Amendment No. 17
License No. DPR-46

ATTACHMENT TO LICENSE AMENDMENT NO. 17
CHANGE NO. 20 TO THE TECHNICAL SPECIFICATIONS
FACILITY OPERATING LICENSE NO. DPR-46
DOCKET NO. 50-298

SUPPORTING AMENDMENT NO. 17 TO DPR-46

CHANGE NO. 20 TO TECHNICAL SPECIFICATIONS

Figure 6.1.1
NPPD Management
Organization Chart

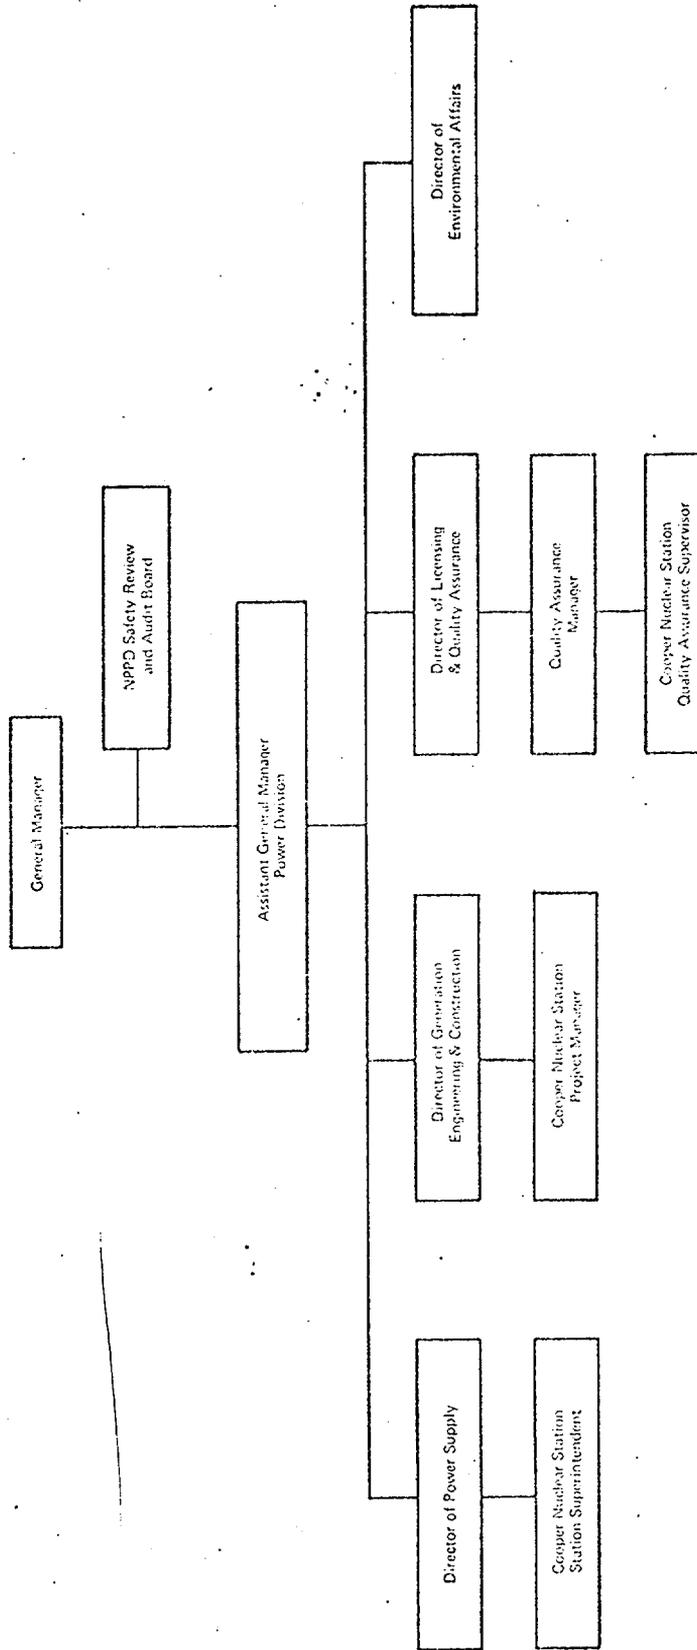
Proposed changes to the NPPD Management Organization include the following:

1. The position of Power Production Manager would be eliminated and all references to the Power Production Manager would be changed to Director of Power Supply.

2. The position of Director of Generation Projects would be abolished; Director of Generation Engineering would be renamed Director of Generation Engineering and Construction and would assume the duties of the Director of Generation Projects.

3. The CNS Project Manager would fill the vacancy on the NPPD Safety Review and Audit Board (SRAB) created by the abolition of the position of the Power Production Manager.

4. The Manager, Licensing and Quality Assurance would be promoted to Director of Licensing and Quality Assurance.

5. The position of Director of Environmental Affairs would be added to the NPPD Organization.

We have concluded that the proposed change shortens the chain of command from CNS to the NPPD management and, therefore, should strengthen administrative control.

This change represents a merger of the functions of the Director of Generation Projects with the Director of Generation Engineering. The duties of the former would become the responsibility of the latter. To reflect the additional responsibilities of the Director of Generation Engineering, the new title of Director of Generation Engineering and Construction would be created. Also, the CNS Project Manager, a position presently under the Director of Generation, would report to the new Director of Generation Engineering and Construction. The NRC staff concluded that this change would be administrative in nature and would not alter the effectiveness of management organization.

The appointment of the CNS Project Manager to the SRAB would not violate the SRAB membership requirements as set forth in the CNS Technical Specification 6.2.1.B.1. The NRC staff has concluded that the CNS Project Manager meets the requirements for SRAB membership.

Because no change in responsibilities or organizational structure would result, we have concluded that the effectiveness of the NPPD organization would not be reduced as the result of this promotion.

This addition of an existing position to the organization chart would be made for the sake of completeness. No changes in responsibility or organizational structure would result.

Figure G.1.2
 Cooper Nuclear Station
 Organizational Chart

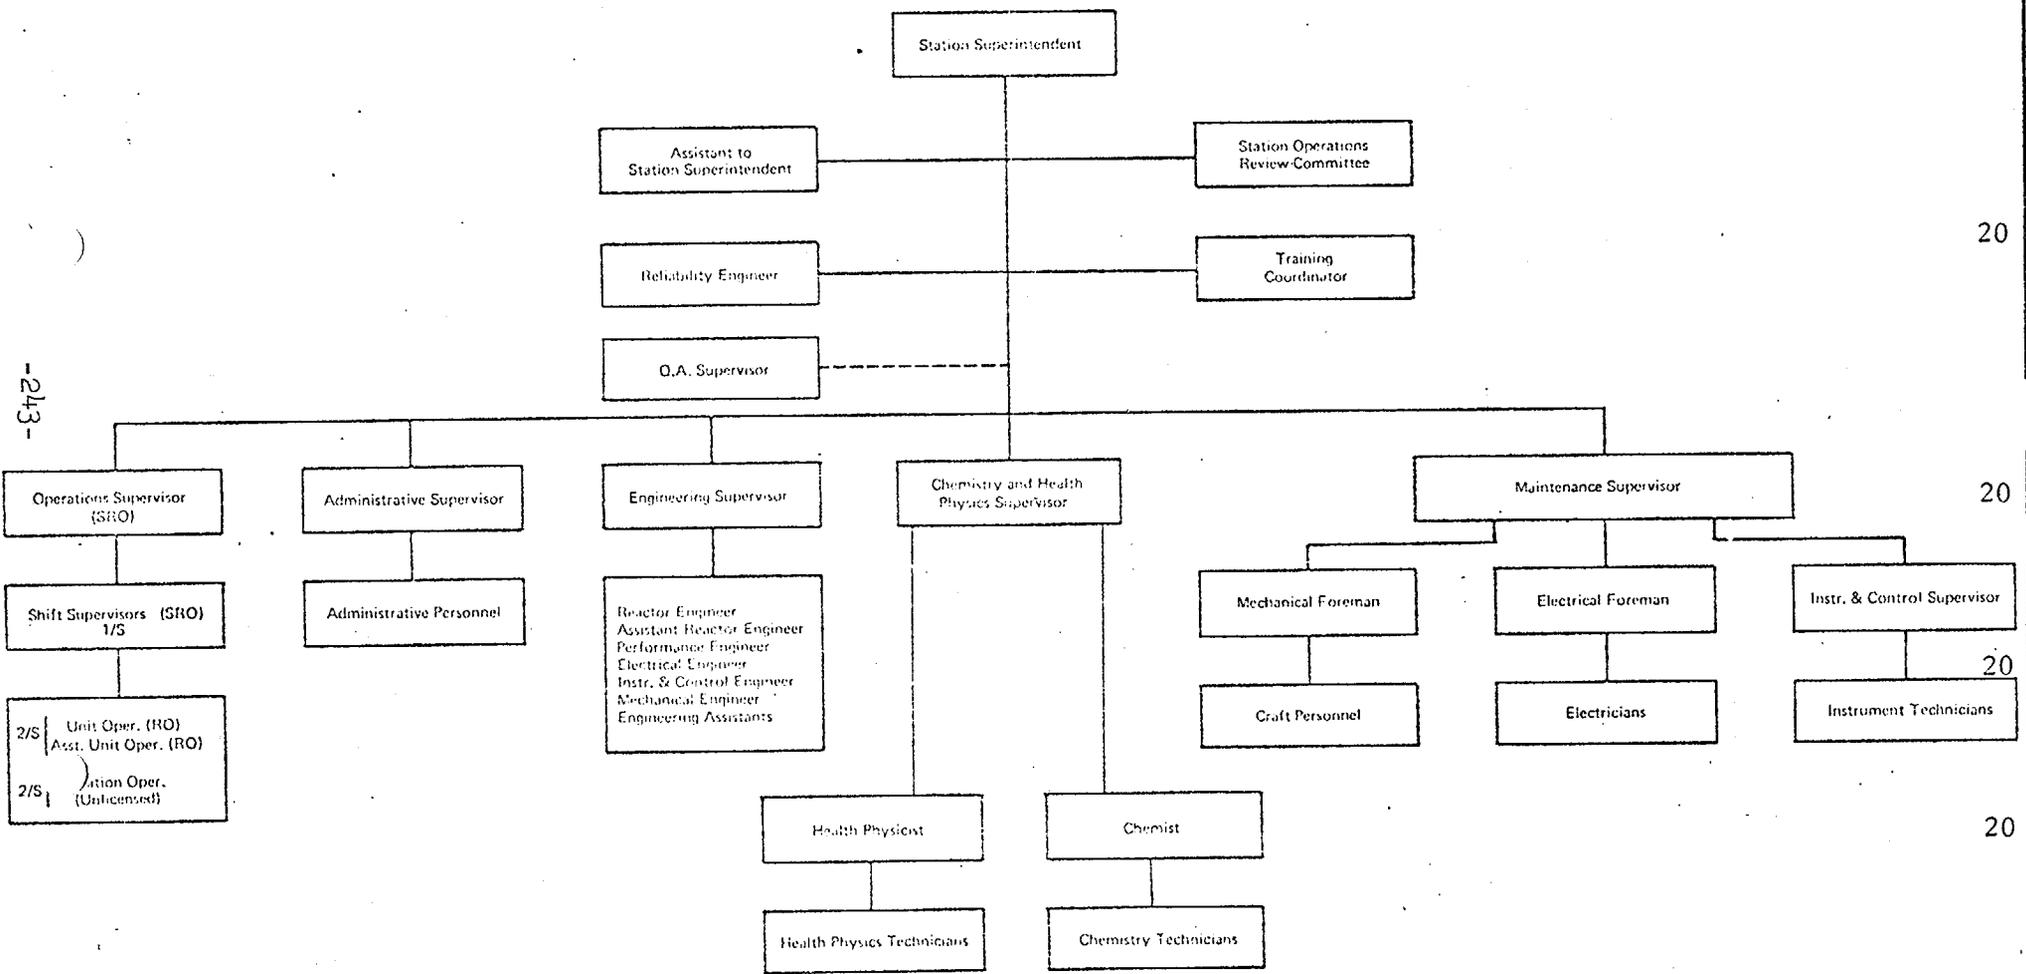
The changes to the CNS Organization would include:

1. The abolition of the position of Assistant Station Superintendent and the creation of an Assistant to Station Superintendent.

2. The addition of new positions of Reliability Engineer, reporting to the Station Superintendent, and Assistant Reactor Engineer, under the Engineering Department.

3. The removal of "key personnel" classification on Figure 6.1.2 for all engineers except the Reactor Engineer.

4. The upgrading of Quality Assurance Specialist to Quality Assurance Supervisor, Assistant Health Physicist to Health Physicist, and Assistant Chemist to Chemist.

proposed Assistant to Station Superintendent, as stated in the Technical Specifications would remain unchanged from the former position, the qualification requirements of this new position could not be correlated to a specification of ANSI-N18.1-1971. Upon request by the NRC staff, NPPD by letter dated September 5, 1975, supplied a revised Technical Specification 6.1.4 which would require the Assistant to Station Superintendent to maintain qualifications per Section 4.2 of the ANSI Standard. Based on the foregoing, the NRC staff concluded that this proposed change would not affect the strength of the CNS organization.

The staff has concluded that the addition of these new positions would not weaken the CNS organization and should, in fact, improve the efficiency of the organization.

The designation "key personnel" has been used to identify facility staff positions for which certain qualification standards applied. The current NRC staff position on facility staff qualifications is set forth in Regulatory Guide 1.8 which endorses ANSI-N18.1-1971. If a facility staff meets these guidelines, the designation of certain staff positions as "key" is unnecessary. In accordance with Technical Specification 6.1.4, CNS is required to meet the standards of ANSI-N18.1-1971. Consequently, the staff has concluded that the classification "key personnel" may be completely removed from Figure 6.1.2.

CNS now has two full time quality assurance (QA) personnel. To identify the senior QA specialist, the position of QA Supervisor would be created. This new position would continue to report to the Station Superintendent. The proposed positions of Health Physicist and Chemist represent title changes only; the duties, qualifications, and organizational location of these positions remain unchanged. Therefore, since no change would be made to the CNS organization or personnel qualifications and responsibilities, the NRC staff has concluded that the strength of the CNS organization would not be altered by these changes.
